Subject: RE: O8W-PM [REDACTED] - Bucks Creek 1101 Phase 1,2&3 - Pre-Engineering Meeting

Bucks Creek 1101- PM# [REDACTED] Overview Map

PM [Redacted] (Phase 1)

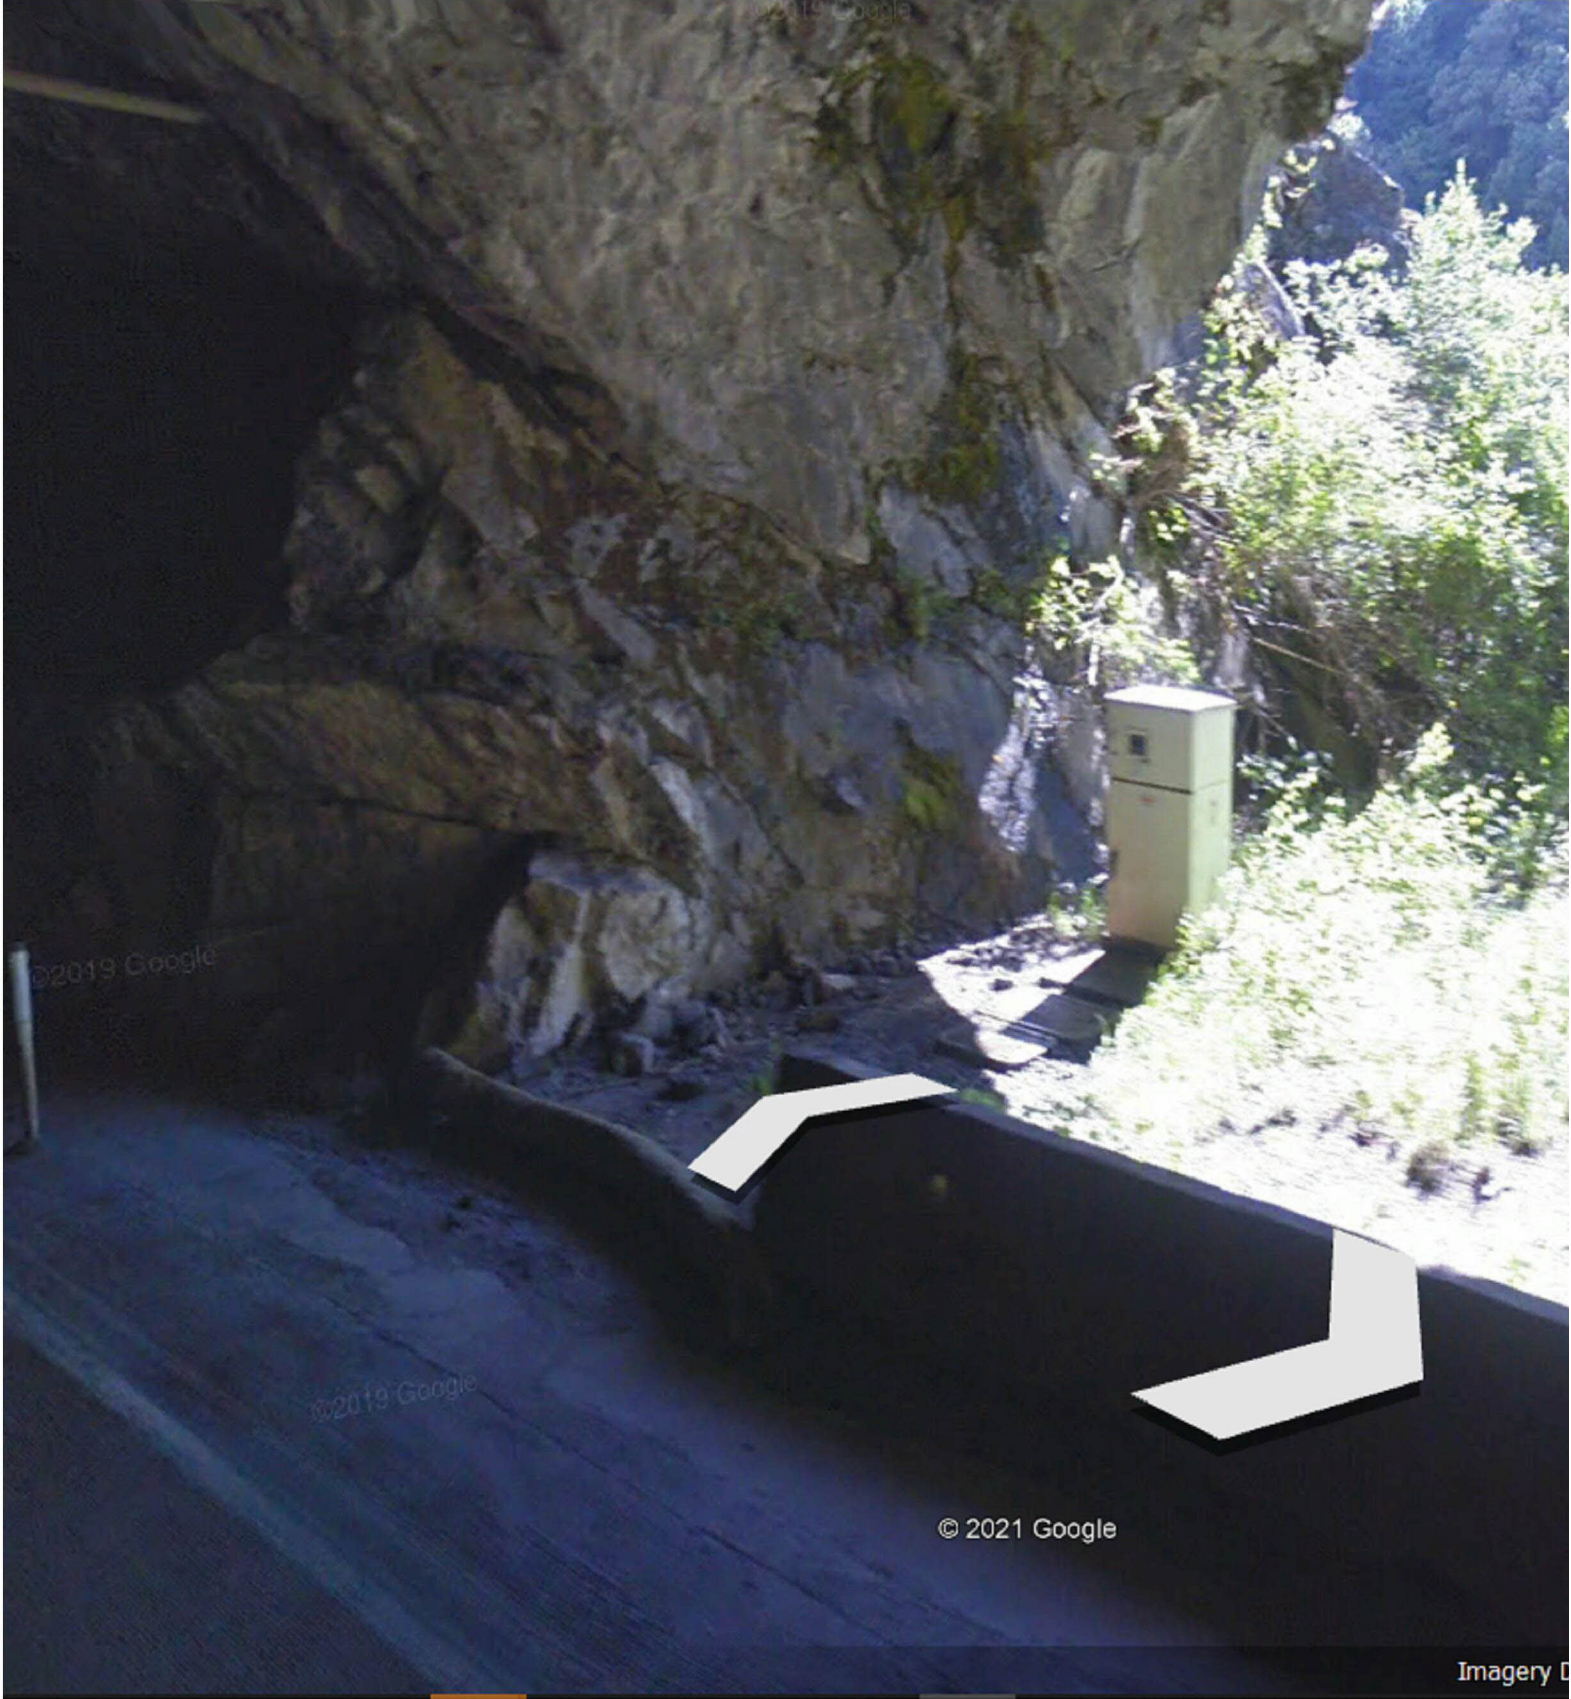
Attached are the 'base-map' limits in a kmz. file. As you will see, we need our base-map to go about ~100' into the tunnel at the south end (see pedestal in picture below...please begin about ~50 beyond this point which is about ~100' beyond the Cresta Dam).

We want to end the base-map at the sign location below which is roughly at MM (Mile Marker) 5.10.

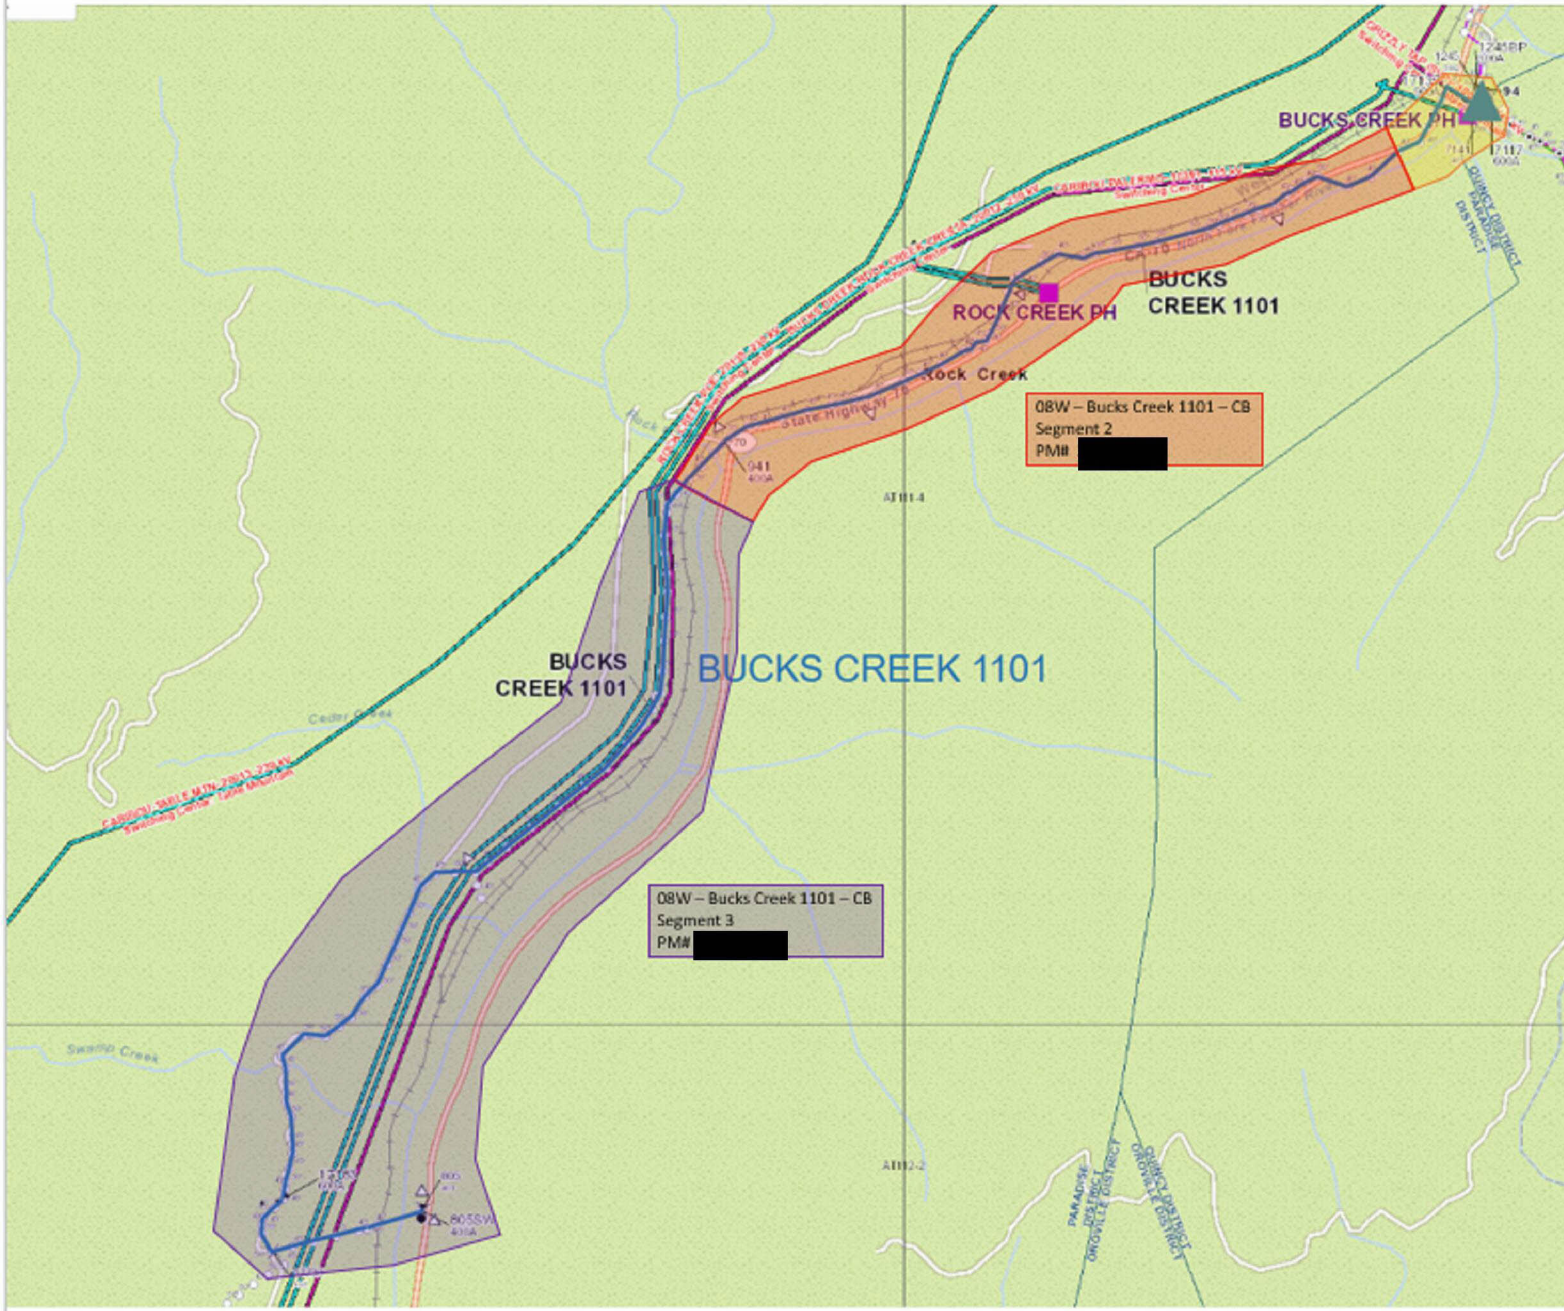
For Bucks Creek there is quite a bit of work surrounding Hwy 70 and we will need a Land Department Base Maps prepared for all 3 Orders. This will delay the EOD dates until these can be developed and provided to the Vendor... We will also need answers to the questions outlined by [REDACTED] below...

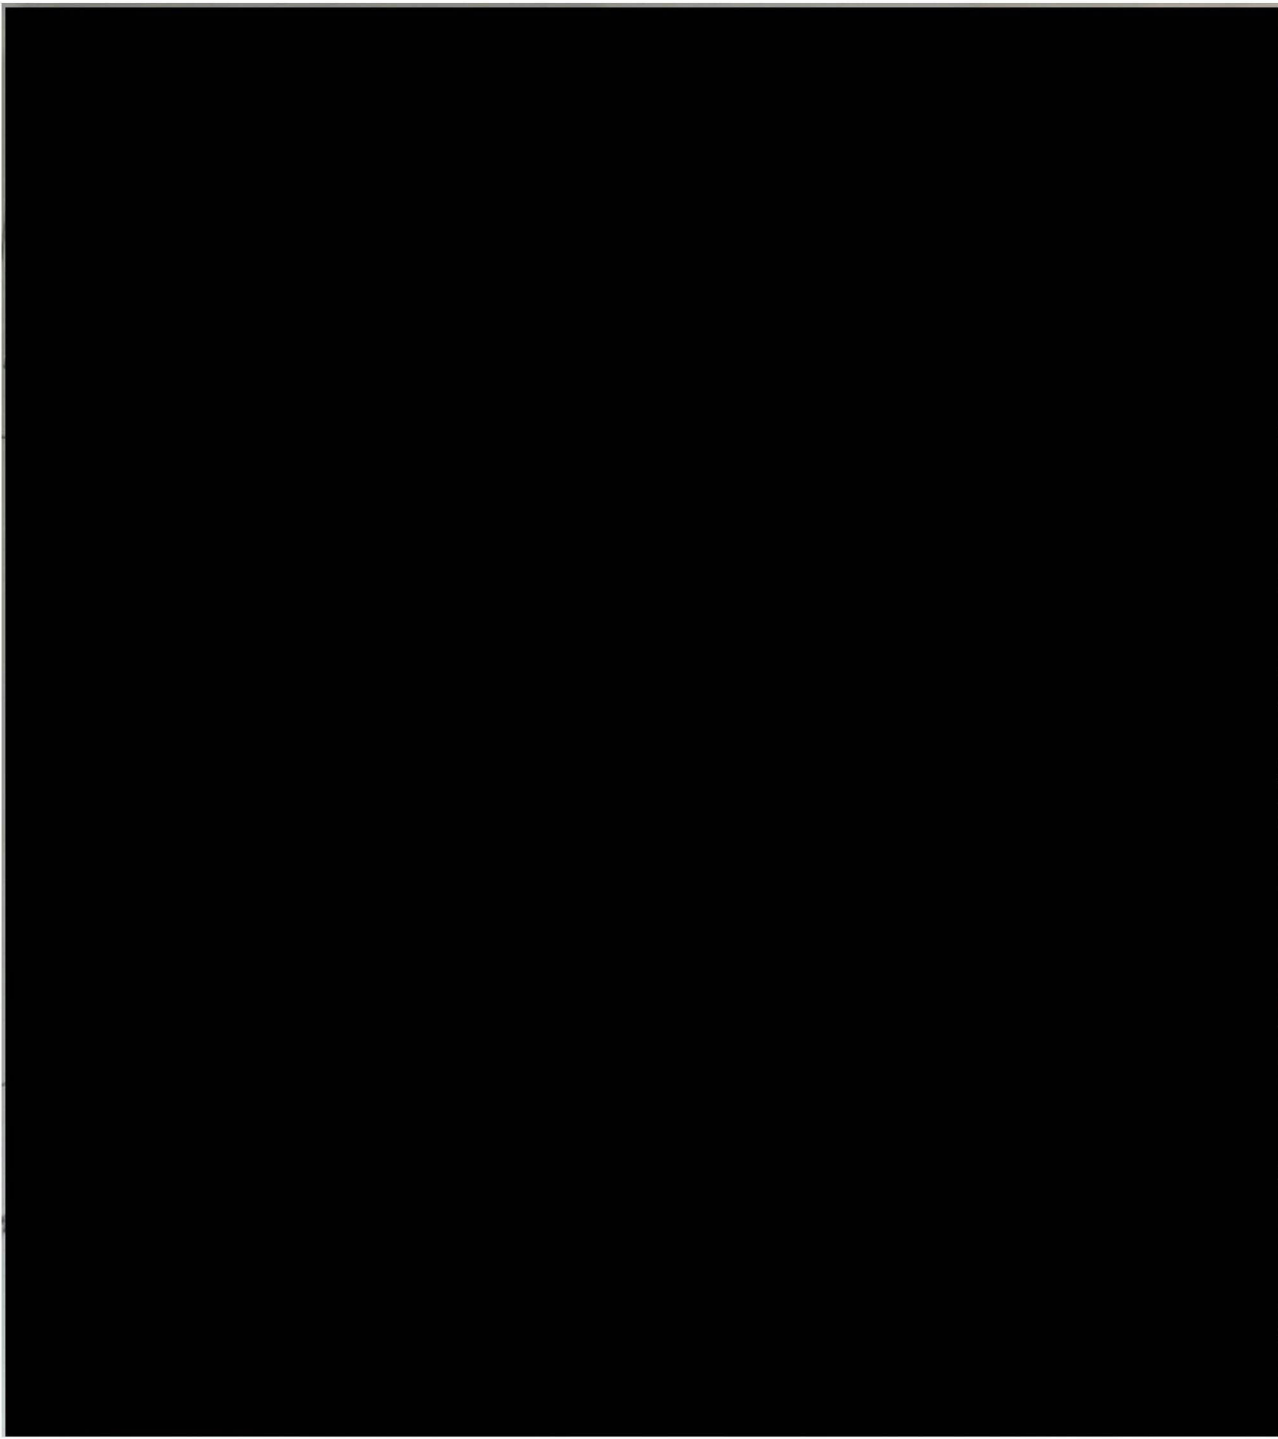
1. We learned the following:
 - a. Sub-Station (per [Redacted] is undergoing its own project under PM [Redacted] of [Redacted] which is in UNSC status, and the following locations have 'overlap' scope:
 - i. Location 1, pole is being replaced under Sub PM
 - ii. Location3, pole is being replaced under Sub PM
 - iii. It appears that PM [Redacted] will be completed before our O8W project begins, so it is imperative that we work to have their scope match our needs...ASAP. I will take this action with the help of [Redacted] to supply the details.
2. Location 2 has a bank of three transformers not indicated in any of our scoping documents....do we really need to replace this steel pole?

3. 'Underground' scope between locations 102 and 101 doesn't make sense when the following are considered:
 - a. How does this scope reduce risk?
 - b. Is 'undergrounding this small section 'constructible' when you consider the following:
 - i. Stairway, creek crossing, and proximity to sub-station
 - c. See picture

3. All parties had the same burning question regarding the 'river crossing';
 - a. Why couldn't we move Location 4 to the east side of CA-70 and remove Locations 5, 6, 7, and 8 of the OH-Hardening scope? This would require an increase in OH-UG scope on PM [REDACTED] of about the same distance of OH-Hardening scope begin removed from PM [REDACTED]
 - b. Here is the basic idea in RED.....the dashed line is proposing UG:
